AMENDMENTS TO THE DRAWINGS

"Film Carrier Tape for Mounting Electronic Part and Screen Mask for Solder Resist Coating"

Attorney Docket No. 1217-031772

Fig. 6

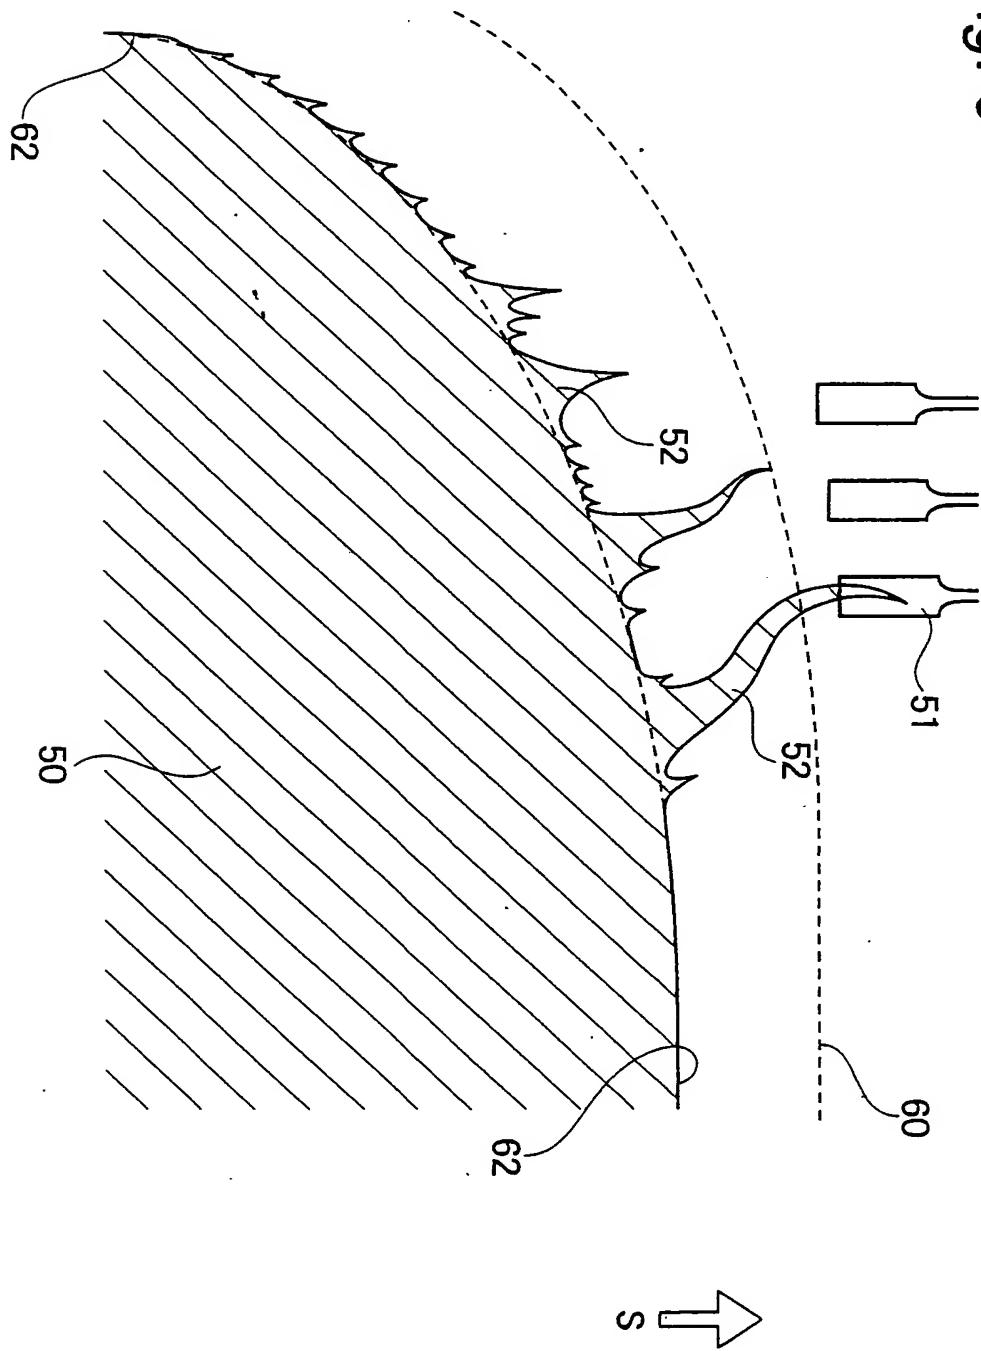
The drawings stand objected to because the Examiner contends that Figures 5-7 should be designated with a label such as – Prior Art --. The Applicants believe that new Figures 5-7 overcome the Examiner's objections. Amendments to Figures 5-7 are indicated in red in the attached annotated copies of Figures 5-7. Acceptance of the replacement drawings is respectfully requested.

The attached sheets of drawings include changes to Figures 5-7 to insert the legend --PRIOR ART--. The replacement sheets, which include Figures 5-7, replace the original sheets including Figures 5-7. Changes incorporated in this sheet are indicated in red on the attached annotated copy of the original sheet.
